'E' MOUNTED SERIES III

With the introduction of the EMU range of machines various alterations have taken place. The machine number and change of part number are listed below. Certain of these alterations

PARTS BULLETIN

SUBJECT: 66221 DUST COVER FOR EIII ROTAVATOR.

HOWARD "E" SERIES

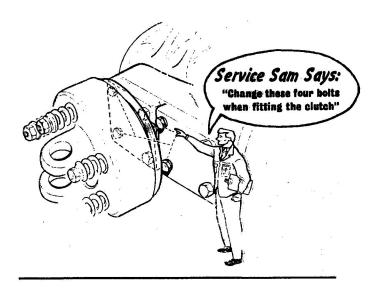
In view of the hard soil conditions we are now experiencing your attention is drawn to the correct method of blading the rotors to the correct scroll formation and in particular to the positioning of the nut and spring washer of the blade bolt. The head of the bolt must be in contact with the blade and the nut and washer outside the flange.

The bolt is specially made to ensure that the shoulder passes through both the thickness of the flange and the blade. Thus the blade is not supported on the threaded portion of the bolt. Spurious bolts should not be used since only high grade nuts can be tightened to the correct torque.

SELECTATILTH GEARBOX COVER PLATE **PART No. 65546A**

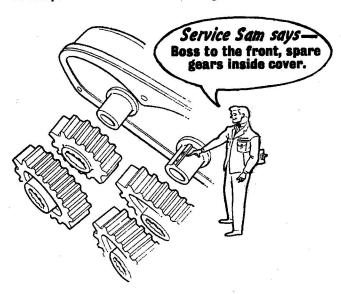
One of the two posts which form part of this cover plate have a slight alteration. The peg, which was fitted to prevent the spare pair of gears from revolving when carried on these posts. has now been deleted. A small "land" is cast into the post and this will prevent the gears from turning by engaging with the gear hub splines.

The cover is completely interchangeable with the earlier type. You are reminded that the spare pick off gears must be fitted inside the cover and that one spline of gear is indented to prevent the gear from being fitted the wrong way round. The correct position is with the boss of the gear to the front.

'E' Series III Selectatilth Gear Box

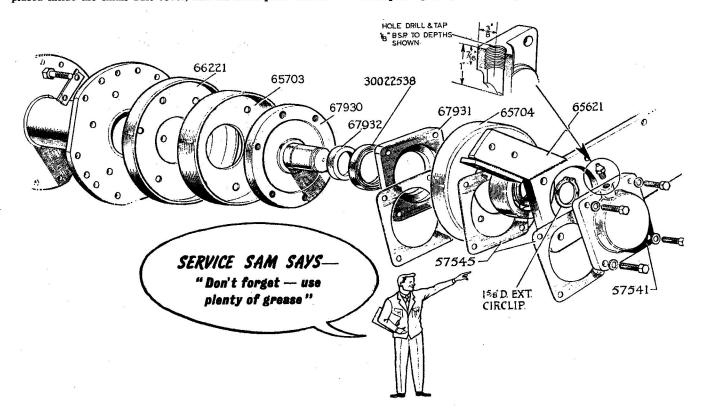
An alteration to the shape of the Front Extension Shaft, Part Number 65541, also the Sliding Dog Part No. 65542, which reduces the machine operation, may be misleading when replacement parts are obtained. In fact interchangeability is not affected in any way, the "wasting" on the shaft has been deleted.

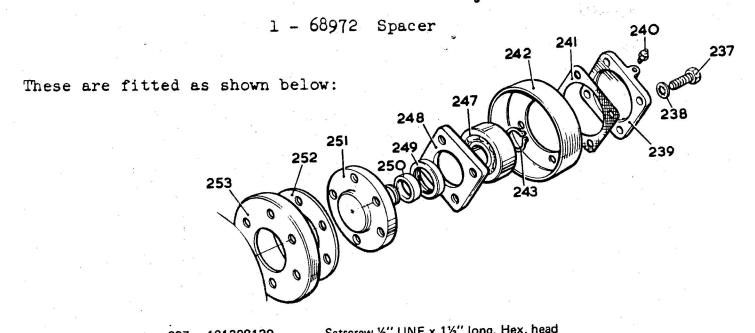
The 66221 Dust Cover is no longer produced and any machines requiring this should be updated using the following parts:

1 - 68971 Dust Cover

The 68971 dust cover replaces the 65704 dust cover, which should be discarded.
